**WILTON PUBLIC WORKS
DEPARTMENT**

DATE: January 5, 2024

RE: 131 Danbury Road, Wilton CT – 131 Danbury Wilton Dev AMS, LLC

This letter is written in response to the review of the submission by Redniss & Mead dated November 17, 2023 for the proposed development on 131 Danbury Road. Based on the review of the above mentioned application at this time, the items listed below shall be addressed:

SITE PLAN - UTILITIES
PROPOSED MULTI-FAMILY DEVELOPMENT
 131 DANBURY ROAD
 WILTON, CONNECTICUT

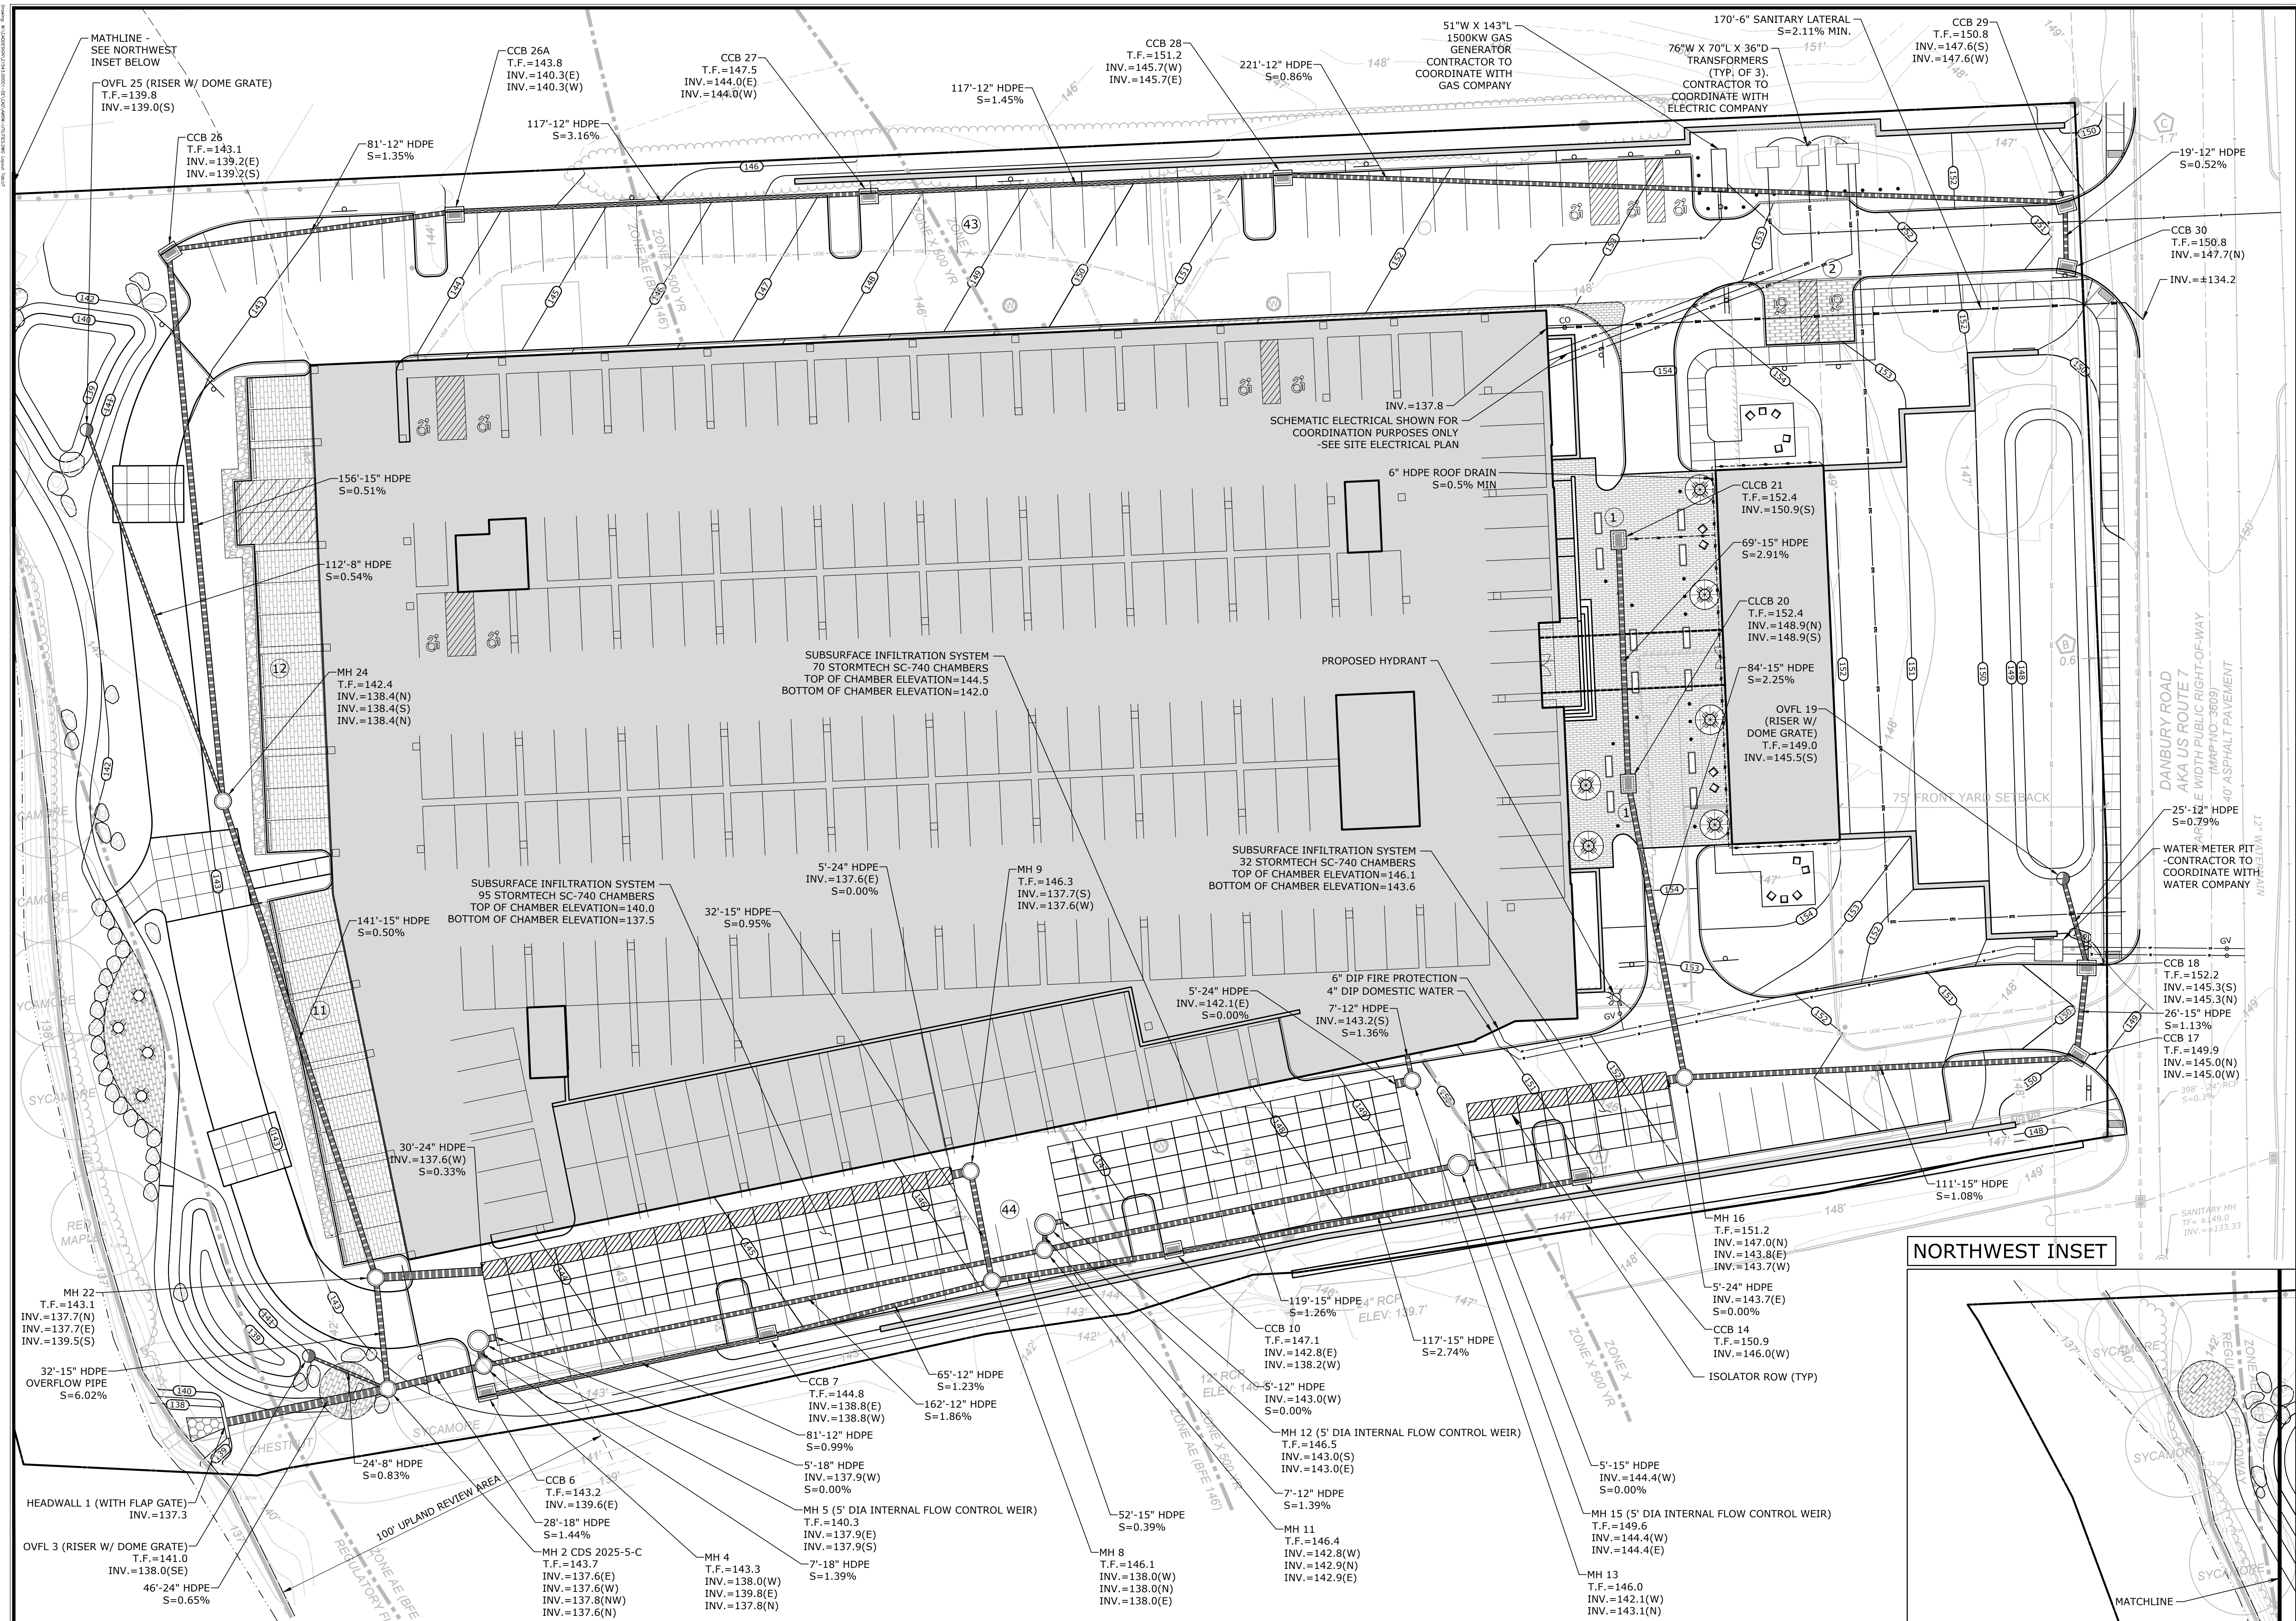
- 4) Design Engineer shall address Norwalk WPCA's review as per email dated 11/28/23.
- 5) Engineer to evaluate the use of an 8" sewer line. The proposed sewer lateral shall be connected to a new manhole along the existing sewer main within Route 7. Modify details.

- 6) Garage drains on the lower level subject to the 100-year flood limits shall tie to an oil separator and not discharge into the sanitary system. Engineer to evaluate other discharge locations (i.e. storm infiltrators).
